1. Identification of Change

CHAPTER 17.0 QUALITY ASSURANCE

17.1 QUALITY ASSURANCE DURING DESIGN AND CONSTRUCTION

WOLF CREEK GENERATING STATION UNIT NO. 1

FIGURE 17.1-1

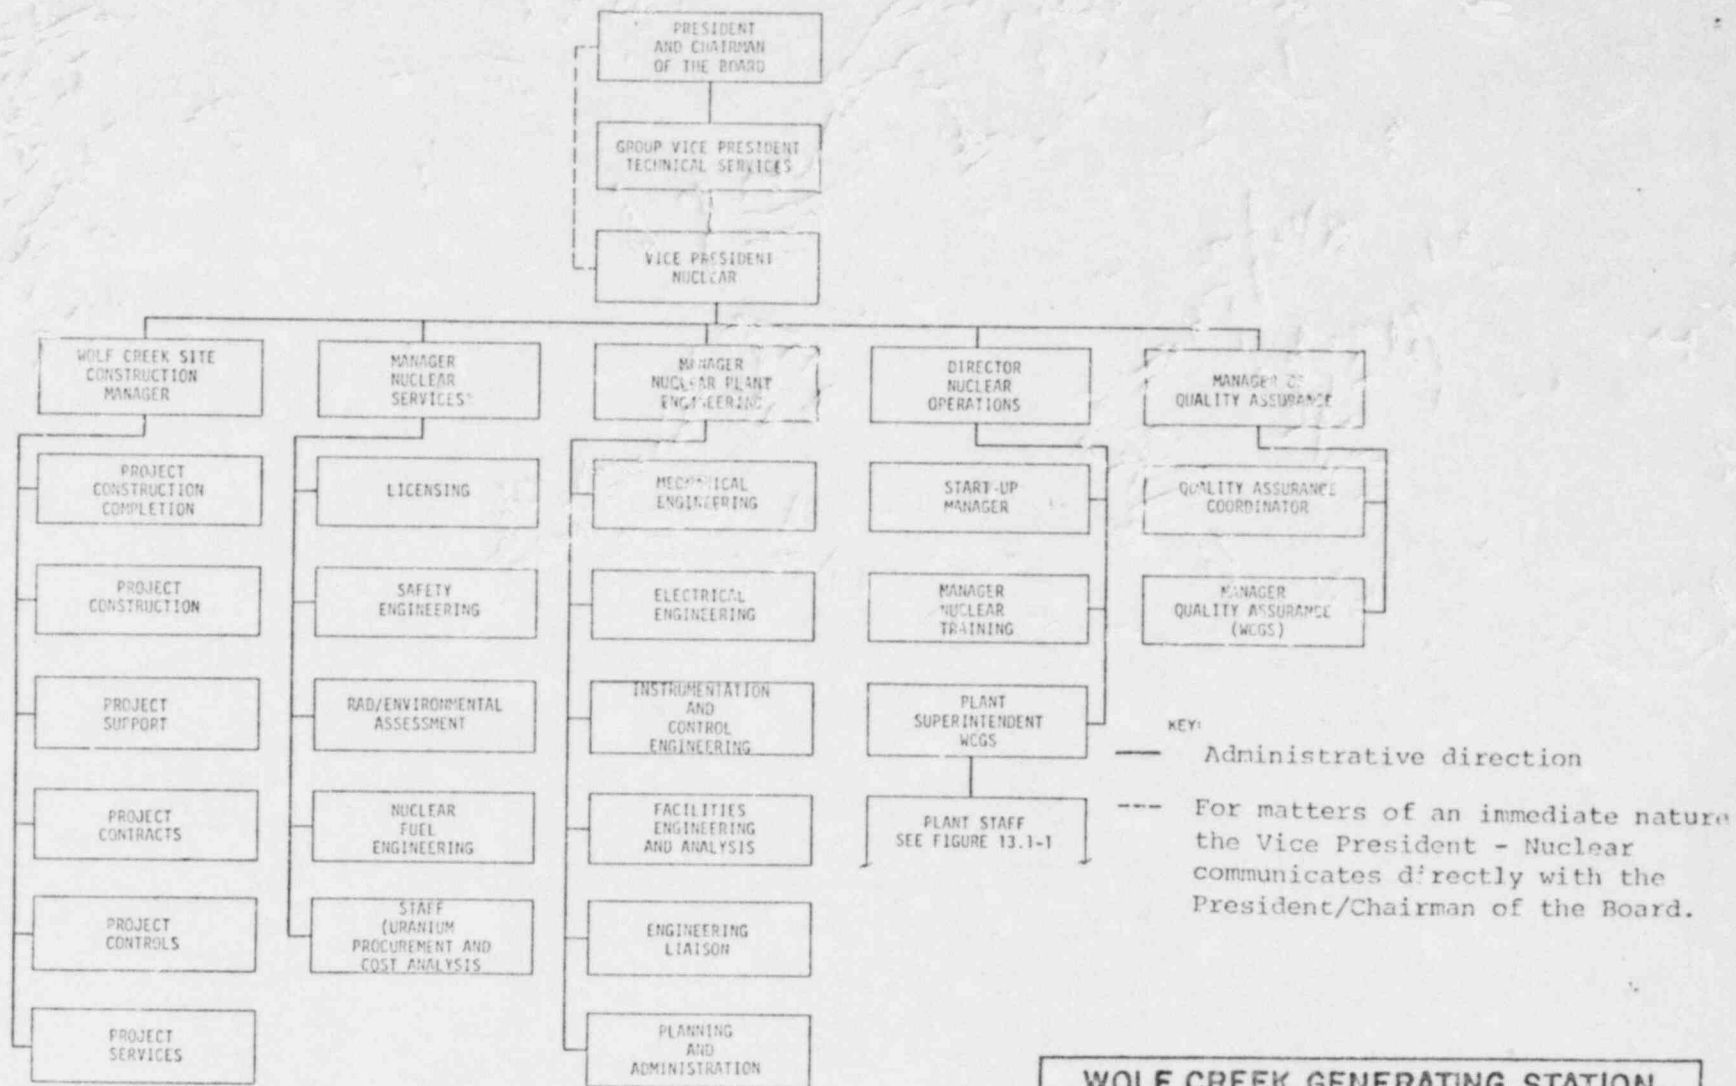
Pages 17.1-1, 17.1-2 (paragraphs 3 and 5 [first and second sentence]), 17.1-3 (paragraph 4), 17.1-4, 17.1-8 (paragraph 3 [first and second sentences]), 17.1-9, 17.1-12, Figure 17.1-1, Figure 17.1-2, 17B-1, 17B-1a, 17B-2, 17B-3a, 17B-3b, 17B-3c, 17B-3d, 17B-4, 17B-4a, 17B-5, 17B-9, and Figure 17B-1.

This change updates the organizational description of KG&E and the Constructor.

The revised organizational description provides delineation of the authority and duties of positions performing activities affecting the safety-related functions of structures, systems and components. The organizational elements performing quality assurance functions maintain sufficient authority and independence as required by Appendix B.

FIGURE 17B-1
DANIEL INTER. CORP.
ORGANIZATION

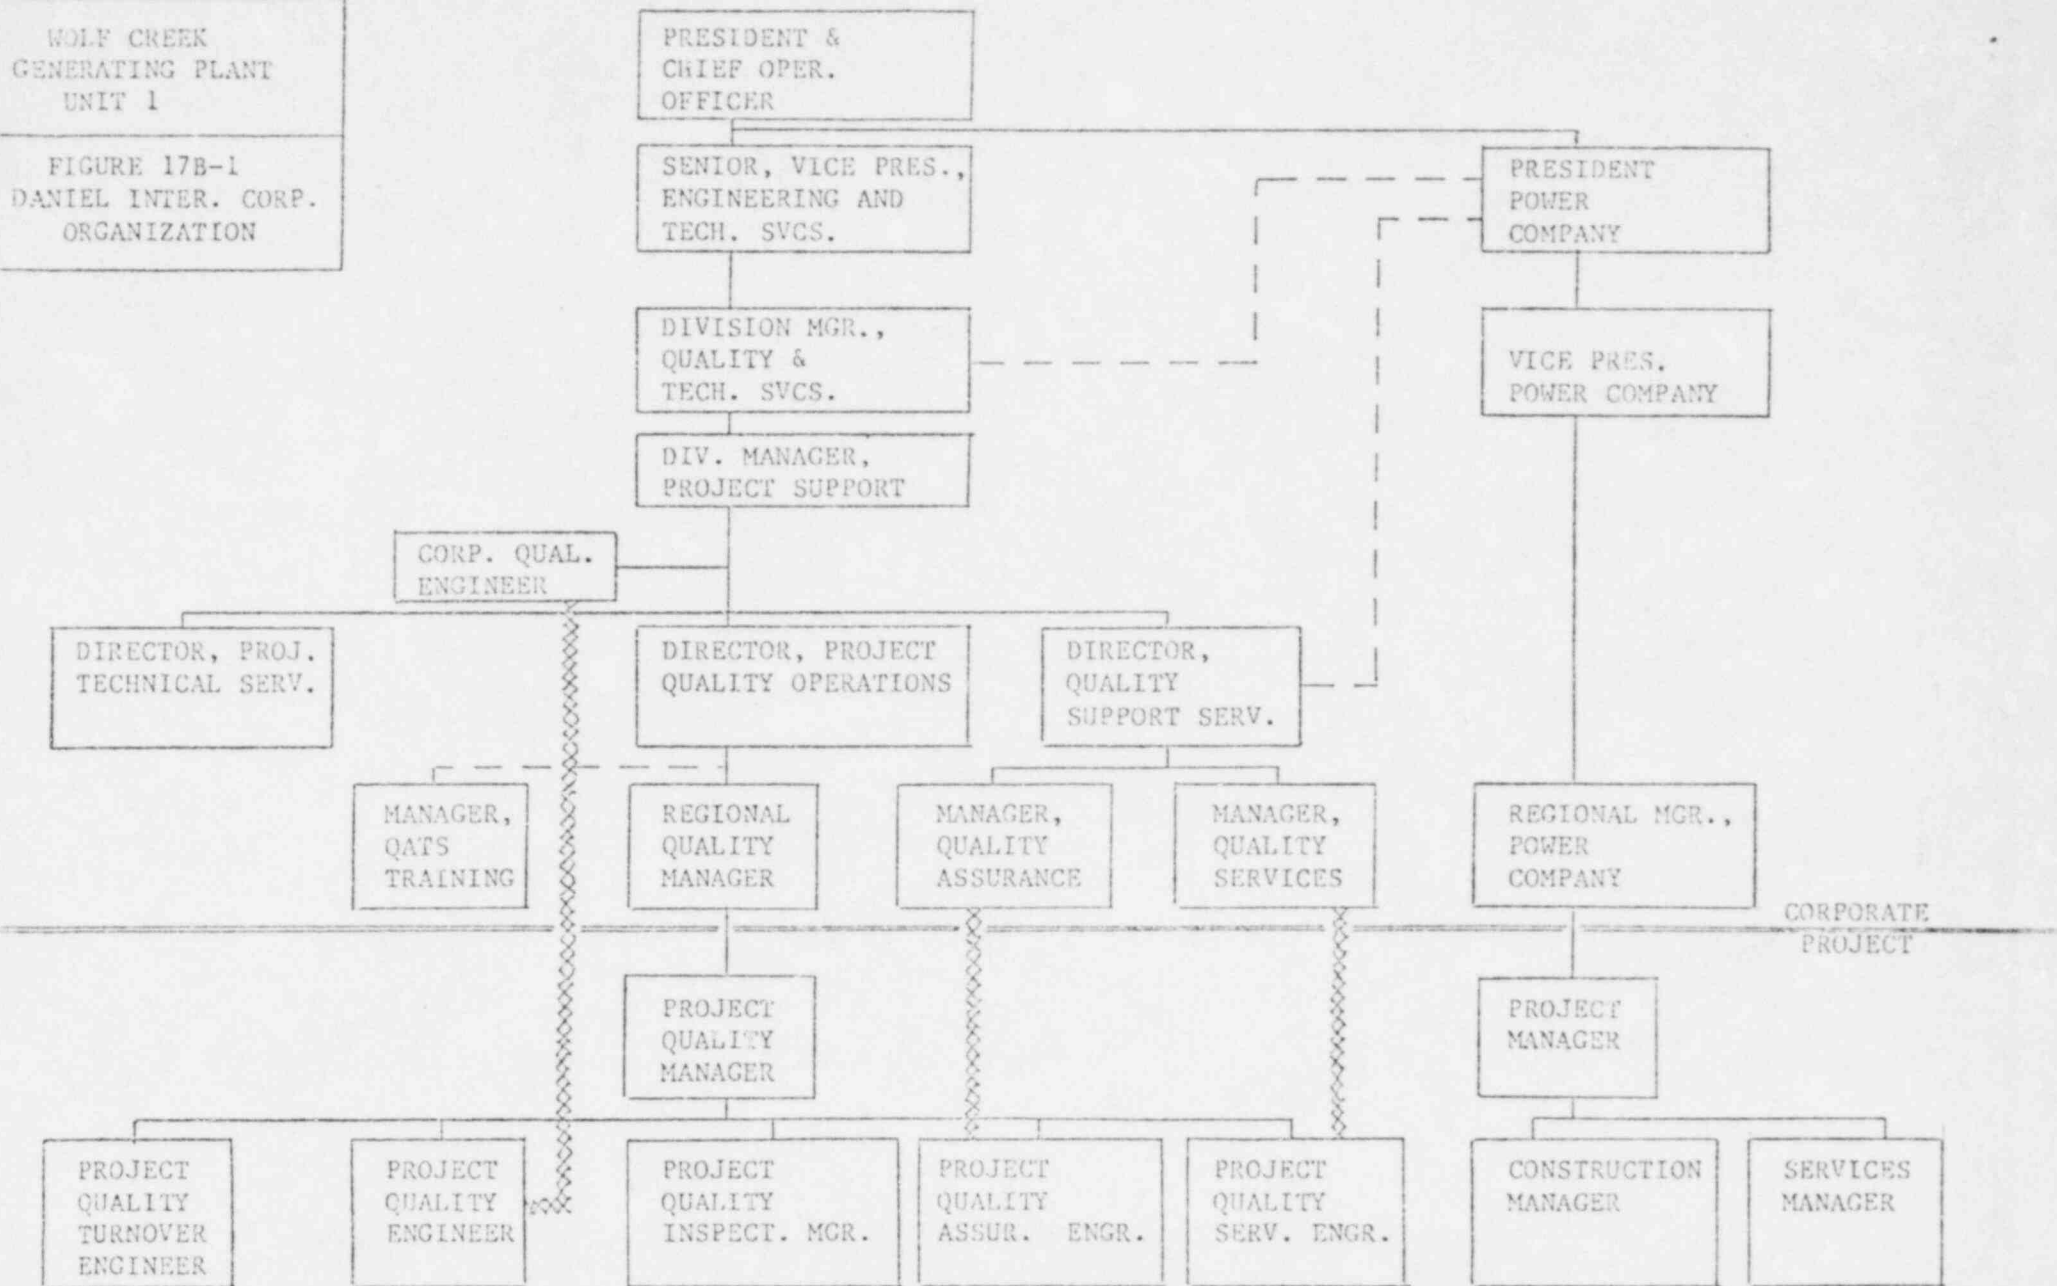
Figure 17B-1 shows the structure and interrelationship of the Daniel International Corporation organizations involved in construction of the Wolf Creek Generating Station. The matrix tie also depicted in Figure 17B-1 is the technical and functional interrelationship between the QATS corporate and project organizations as differentiated from the managerial interrelationship.
